Item No. 27 Encroachment Agreement – Tyndall Park Community Centre (Point Douglas Ward)
eFile ED(34)

Title: **Proposed Encroachment Agreement with Tyndall Park Community Centre**

Issue: **Proposed Encroachment Agreement to Remove the Current Sign at the Community Centre and Replace and Maintain a New Illuminated Sign Encroaching onto the Right-of-Way at King Edward Street and Burrows Avenue – Tyndall Park Community Centre**

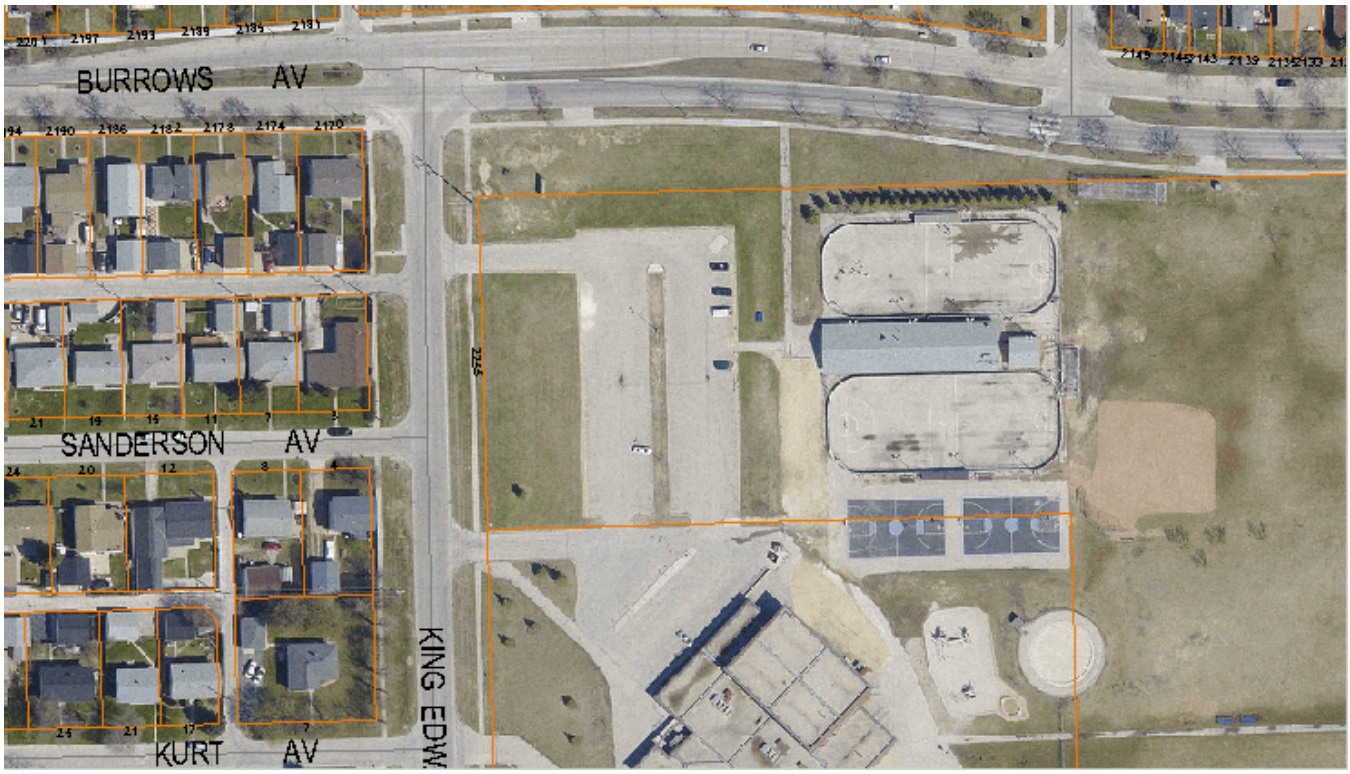
- As shown in the sketch attached, the existing sign is currently located directly over an existing water main. The proposed sign

cannot be located over the water main. It is recommended that the sign be located either north or south of the water main with a 2.0m minimum separation between the water main and the closest support column and pile.
